Attachment C

Engagement Report

Engagement report – Cycling connection between King and College Streets

Appendix A: feedback left on interactive map

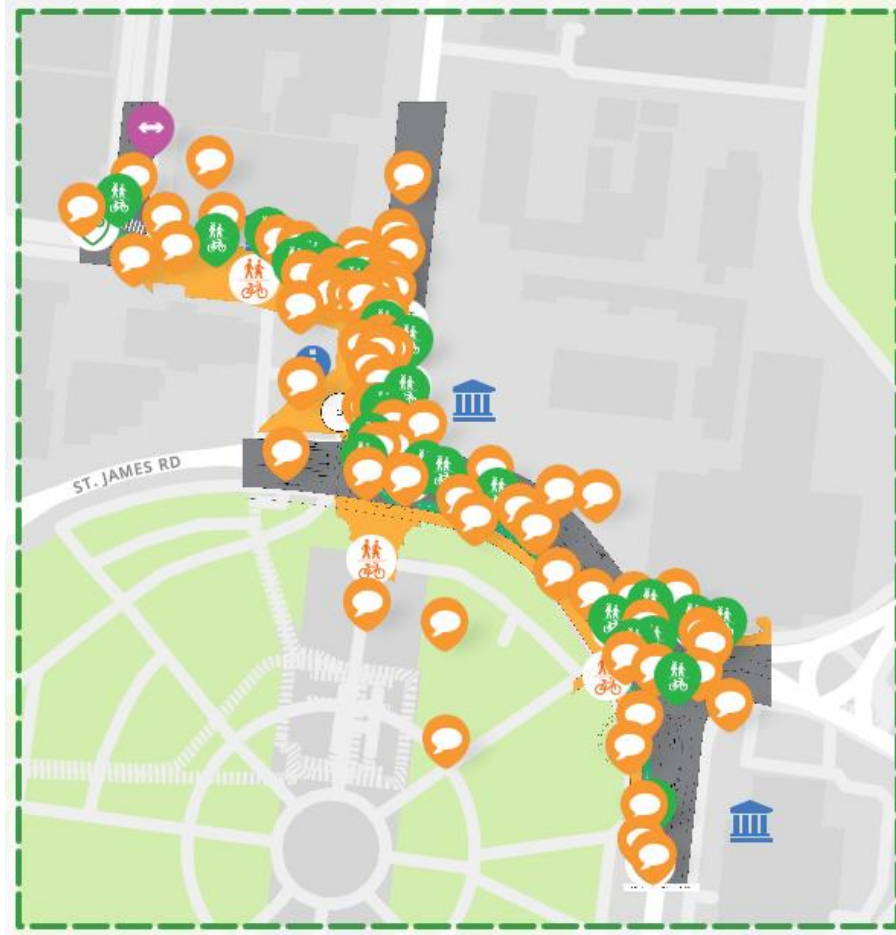
Location	Comment	CoS Response	Count	Up	Down
All	Support		27	337	2
Queen's Square	Physical separation between people walking and riding is needed	The section through Queens Square will remain as a shared path area, with new pavement markings to make clear that pedestrians have priority.	25	1	0
Queen's Square	Please address the steps/lip of the stairs.	An upgrade to Queen's Plaza is not part of the project scope, however pavement marking will be considered where needed.	6	89	0
College Street south of Prince Albert Road	Provide gap in the barrier for people riding to continue into Prince Albert Road	This will be resolved during design development.	3	27	0
Macquarie Street	Allow for people riding north to join Macquarie Street traffic lanes	This will be resolved during design development.	3	14	0
Queen's Square	Have separation between people walking and riding at the same grade. Example in Bondi Junction	The section through Queens Square will remain as a shared path area, with new pavement markings to make clear that pedestrians have priority.	3	33	1

Macquarie Street	Extend the cycleway up Macquarie Street	A cycleway to Macquarie Street north is not part of the project scope.	2	33	1
Macquarie Street at Hyde Park	Make sure the barrier extends all the way to the traffic lights	This will be reviewed during design development.	2	44	0
Macquarie Street at Hyde Park	Use green paint throughout	The design will use green cycleway paint on on-road sections at vehicle conflict points, as specified in guidelines and as on other cycleways.	2	35	0
Macquarie Street	Place additional sensors to trigger bike signal prior to the intersection so as avoid missing their turn	This will be reviewed during design development.	2	9	1
College Street at Prince Albert Road	Have a turning lane into Prince Albert Road and start the 30km/h area at the intersection	This will be reviewed during design development.	2	30	0
All	Make sure there is a fair traffic light phasing for people walking and riding	This will be reviewed during design development.	2	33	0

Queen's Square	The shared area is good as it is, does not need green paint. Work needs	A public domain upgrade to Queen's Plaza planned in future. There will not be green paint in	2	3	0

Location	Comment	CoS Response	Count	Up	Down
	to be done on the lip/steps	Queens Square – it will remain shared path. Markings will be considered where there are lip/step.			
Macquarie Street at Hyde Park	Make the intersection raised and continuous to ensure priority for people walking and riding. Eg Greenknowe and Macleay	A full intersection upgrade is not part of the project scope.	1	18	0
Macquarie Street at Hyde Park	Build out the footpath at the intersection on the northern edge of Hyde Park	A footpath upgrade in that area is not part of the project scope.	1	31	2
St James Road	Realign the lanes on St James Road	Realignment of travel lanes is only considered where needed	1	11	0
Macquarie Street at Hyde Park	Ensure easy access from the park on to the cycleway at both St James Road and Prince Albert Road	This will be reviewed during design development.	1	21	0
College Street at Prince Albert Road	Provide waiting space for people riding to cross and join Prince Albert Road	This will be reviewed during design development.	1	17	0

College Street at Prince Albert Road	Continue barriers but retain a gap for people to cross	This will be reviewed during design development.	1	14	0
Phillip Street	Make the crossing raised	A crossing upgrade in that area is not part of the project scope.	1	2	0
Macquarie Street	Automate bike signals	Bike signals at intersections are triggered via sensors on the cycleway and, in the CBD, automatic during daytimes during the week.	1	2	0
Macquarie Street	it would be safer for the curb not to have a sharper corner to limit potential confusion for left-turning motorists	This will be reviewed during design development.	1	18	0
Hyde Park	Remove redundant shared zones and clearly demarcate which paths inside the park are shared zones and which aren't	All paths in Hyde Park are shared paths to enable people to reach the various parts of the park.	1	9	9
Queen's Square	Provide shared path signage and direct people riding to dismount if there is a lot of people walking	When a place is very crowded, many people riding find it easier to walk their bike, but this might not be suitable for people with disabilities, mobility difficulties or children.	1	2	10

Location	Comment	CoS Response	Count	Up	Down
Queen's Square	Provide shared path signage	The project will include shared path signage and pavement markings.	1	36	2
All	Make sure that cycleway access is safe and entry/exit is not too sharp	This will be reviewed during design development.	1	12	0
All	Retain the existing shared paths even adjacent to the cycleway	This will be reviewed during design development.	1	17	0
Queen's Square	Avoid the use of bollards to demarcate the shared area	This will be reviewed during design development.	1	1	0
Queen's Square	Connection through the square should avoid any existing bollards or poles	This will be reviewed during design development.	1	1	0
Macquarie Street at Hyde Park	Configure traffic lights so that people riding southbound have two opportunities to cross. First, green light for southbound cyclists turning east along the cycle path. Second, green light for southbound cyclists continuing south into Hyde Park	This will be reviewed during design development.	1	2	0

Art Gallery Road	Suggest traffic treatments outside of the Gallery	Art Gallery Road is not part of the project scope.	1	0	0
Macquarie Street at Hyde Park	Make the intersection scatter crossing and provide more time for people walking and riding to cross	This will be reviewed during design development.	1	1	0
All	Open sections as soon as they are complete, don't wait for full completion like College Street	The cycleway will be open once it is completed and safe to do so (sometimes there is a delay waiting for the signals to be changed).	1	5	0
Prince Albert Road	Extend the shared path on the north side of Prince Albert Road	Prince Albert Road north is not part of the project scope	1	7	0
Queen's Square	Widen the footpath next to the statue for people walking	The project will provide a separated cycleway beside this location, so that the footpath near the statue is only used by people walking.	1	6	0
